Amendment C10/11 – text proposition – 06/2025

Allow the use of P1 port as alternative to an EnFluRi sensor

Proposal for public consultation (24/06/2025 to 24/07/2025 at 5pm)

Figure 2 – Example of a DC-connected energy storage system (hybrid system)

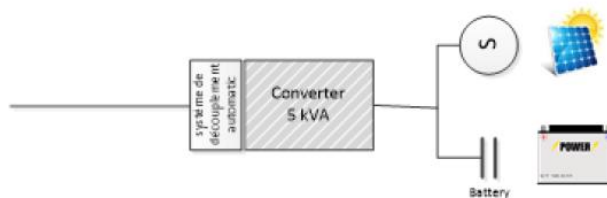
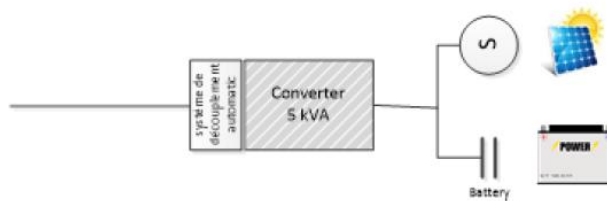
- An energy storage system that have the possibility to inhibit power injection into distribution network by software (with the exception of a non-parametric firmware out of the factory out of the factory) is considered being technically able to supply energy to the distribution network and therefore covered by this definition.
- A direct current connected energy storage system with another means of power-generation is considered a non-synchronous power-generating unit, and is also called a hybrid system.
